Cultural Heritage Subcommittee (CHSC)

Meeting Date: May 24, 2023

SUBJECT: **Cultural Heritage Permit 22-148, Architectural Permit 22-162, Nielsen Residence**, a request to consider: 1) an addition and exterior changes to a historic single-story residence, 2) construction a detached garage with an Accessory Dwelling Unit on the second floor that requires a height limit increase, and 3) changes to the garden landscape and hardscape. The site is located at 222 West Mariposa.

Image 2 – Excerpt of Proposed Roof Plan

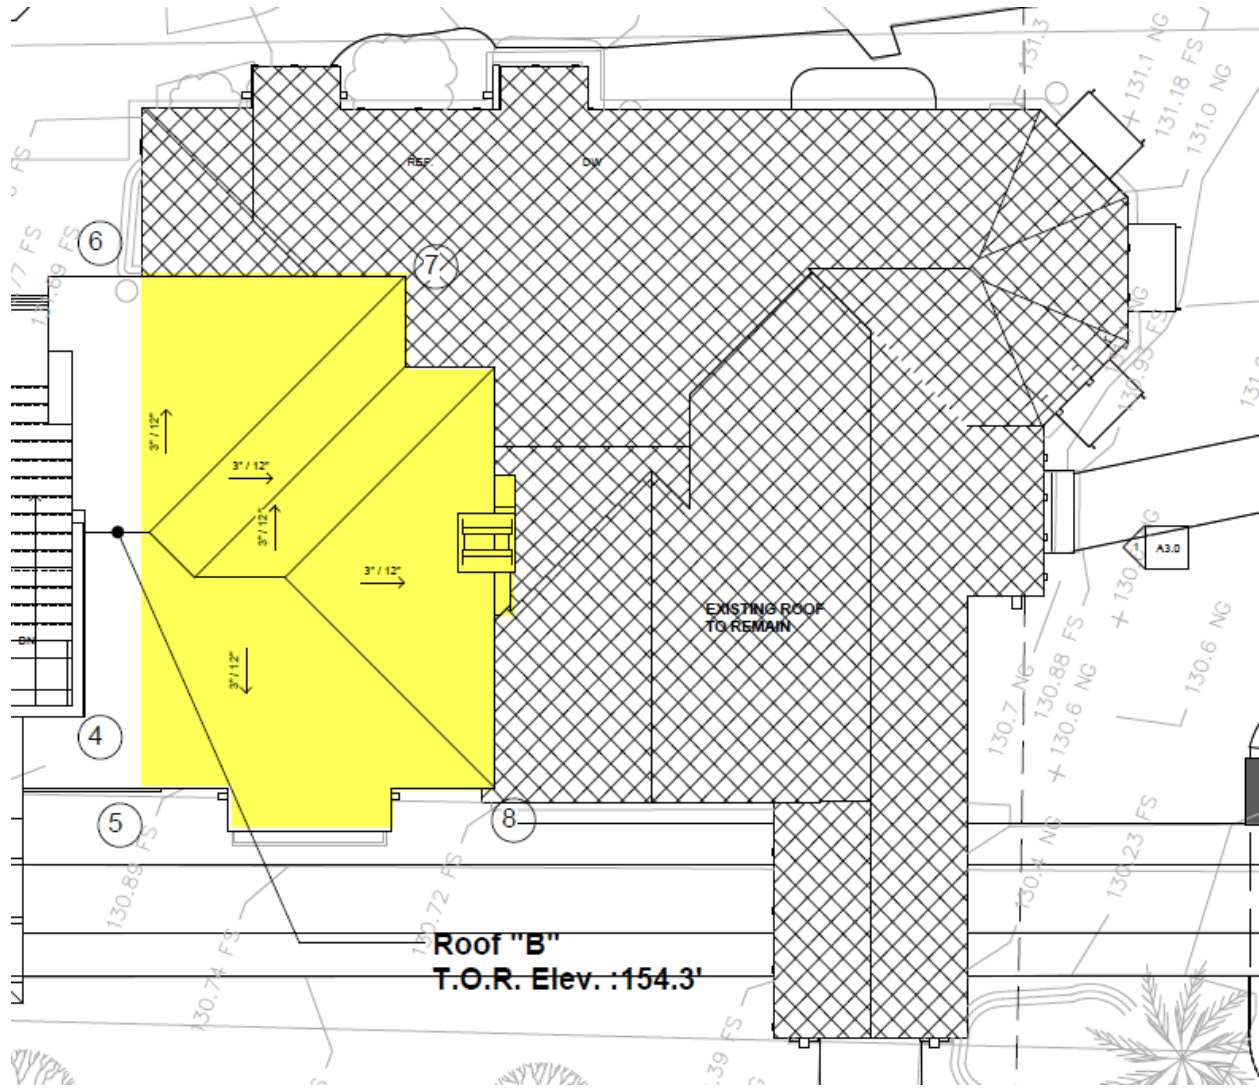
The project adds a 648 square-foot second story over the original structure with the removal of the original roofline and area. Image 1 shows the west elevation where the second-floor addition is proposed. The original roof between the red and orange lines would be removed. Excerpts of the proposed roof plan and west elevation are on the next page.

The original roof area that would be removed for the second-floor addition is highlighted yellow.

Staff's position is that these changes are inconsistent with the Secretary of the Interior Standards 9 and 10 for Rehabilitation of Historic Structure that relate to additions and alterations.

The proposed design destroys historic materials, features, and spatial relationship of original structure with the removal of the roofline and the massing of the addition over the original first floor. If the second-floor addition were removed, the original roofline, massing profile, and general spatial relationship would require restoration.

Image 3 – Proposed West Elevation

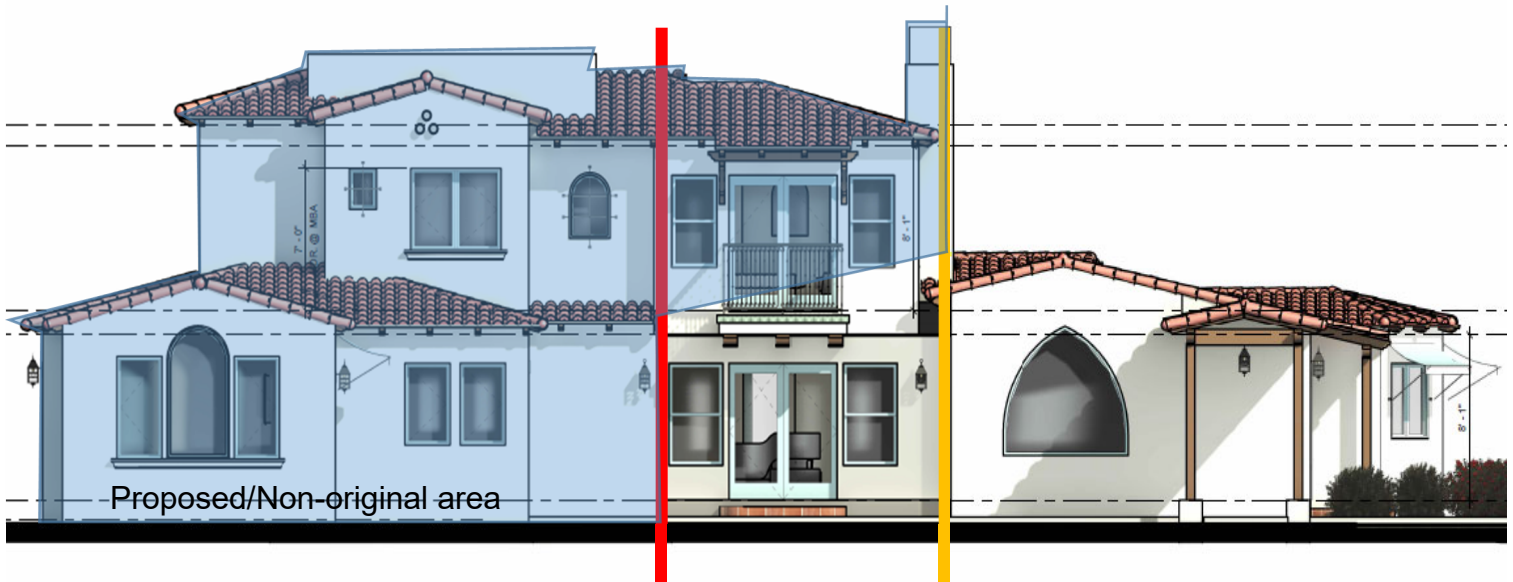
Image 3 shows the proposed west elevation. The original footprint is to the right of the red line. The second-floor addition is proposed over the original footprint between the red and orange lines where the roof would be removed according to Image 2. The blue shaded area is the profile of the proposed addition.

Image 5 – Proposed first-floor excerpt
(grey = proposed addition)

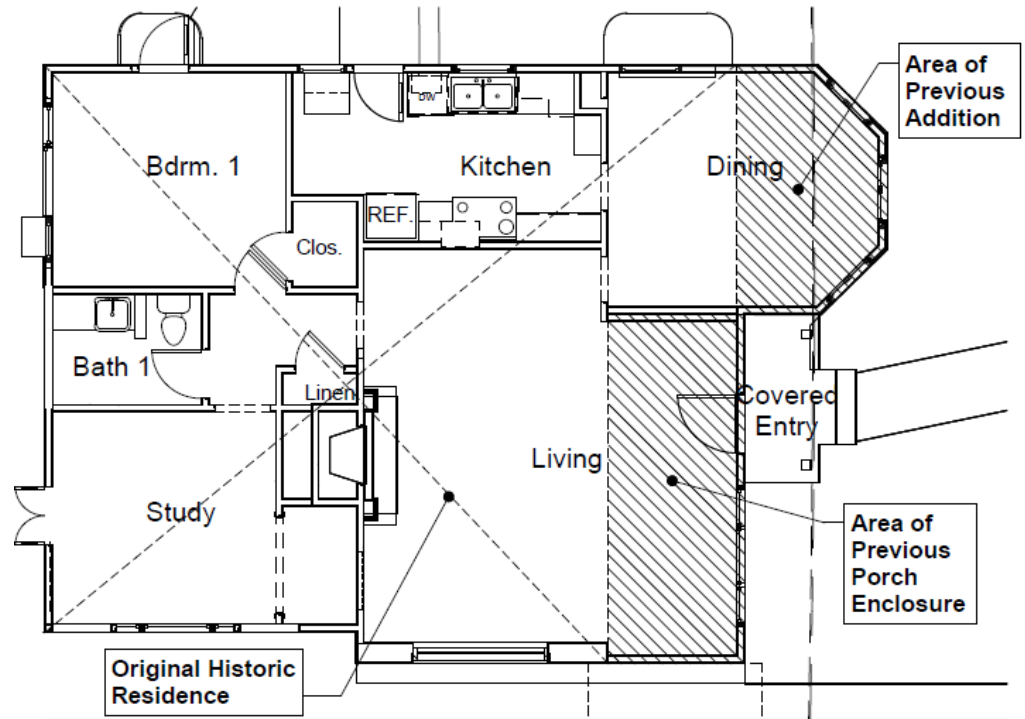
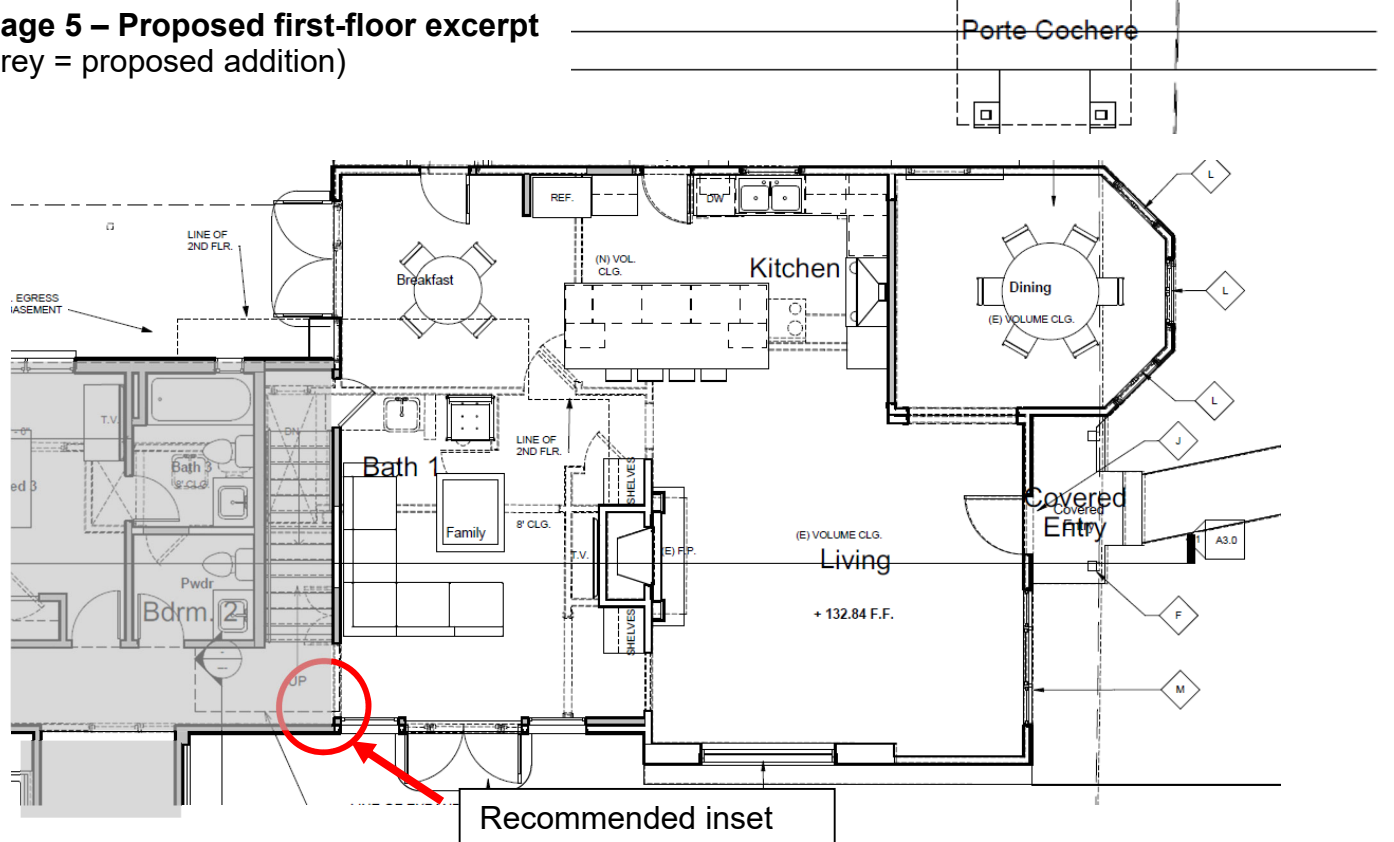
Secretary of the Interior Standard 10 calls for differentiating additions and alterations from original significant elements of a resource. The current design expands the building in-line with the original first floor. Staff recommends varied texture and color, and a spatial break 1-2 inch inset between the original structure and addition to differentiate the addition, consistent with Secretary of Interior standard nine (cited on page above).

Image 6 – Excerpt of Proposed Landscape Plan (red arrows show the tree significant trees along street)

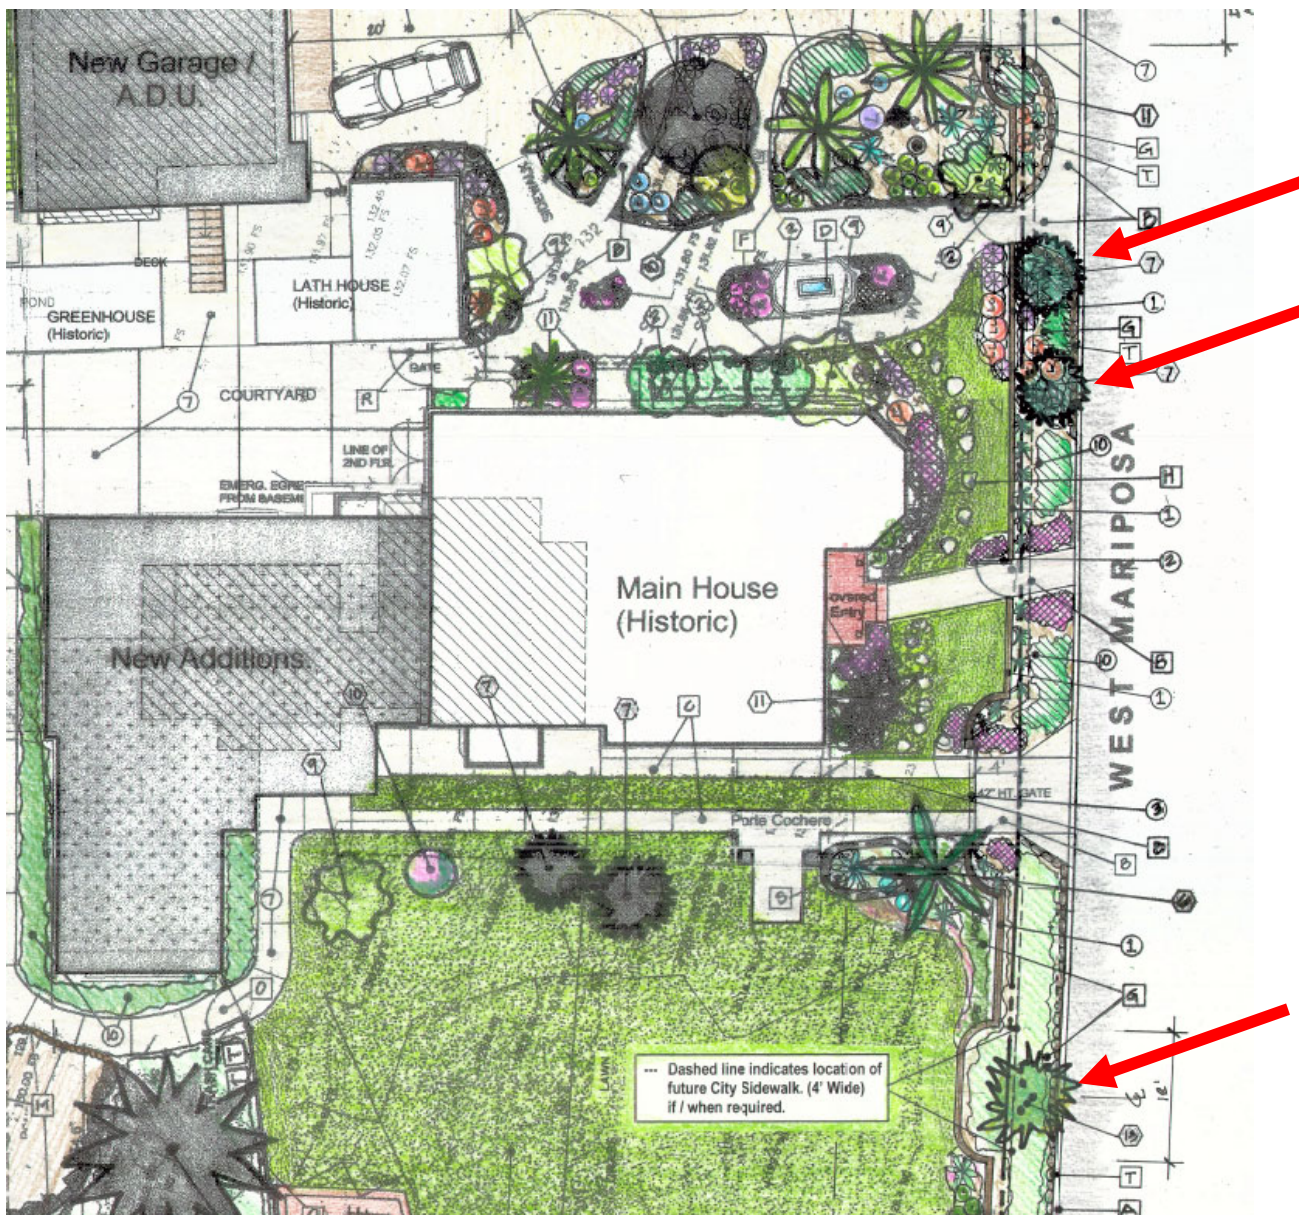
The Municipal Code requires the installation of sidewalk for development projects valued at \$50,000 or more, including the proposed project. However, the site is unique in two ways. First, the Casa Romantica and the subject site are the only known historic resources with historically significant gardens. Second, the subject site is the only known property on the City’s listed of designated historic structures with historically significant trees in close proximity to a street frontage that would interfere with the installation of the sidewalk. There are three trees near the street that are character-defining features to the property’s significant garden: a Yucca and two Japanese White Pines (“bonsai trees”). Image 6 shows the location of these trees.

Ideally, these trees would be preserved to maintain the integrity of the resource. While the City has a sidewalk waiver process, the eligibility criteria does not address waiving a sidewalk to preserve historically significant trees and garden features. The application initially had a design that kept the historically significant trees along the street without a sidewalk installation. During the Development Management Team (DMT) process, the City staff considered several options for the sidewalk:

The applicant decided to redesign the plans to include a sidewalk and replace the trees in-kind, mostly due to the uncertainty of whether the Planning Commission would support option 1 to defer a sidewalk for the tree preservation. The application materials do not provide details on the "in-kind" replacement in terms of the type, size, or location of replacement trees. Additionally, the historic report analysis does not describe how and if replacement trees maintain the resource's integrity based on federal standards.

Staff supports option 1 to defer the sidewalk and add a condition on the Historic Preservation Property Agreement (HPPA) that requires installation of a sidewalk upon the death of the historic trees. The Community Development Director may add conditions to the HPPA but staff would seek guidance from the Planning Commission when it acts on the project. Staff requests CHSC feedback on this important issue so the applicant has information to decide how to proceed.
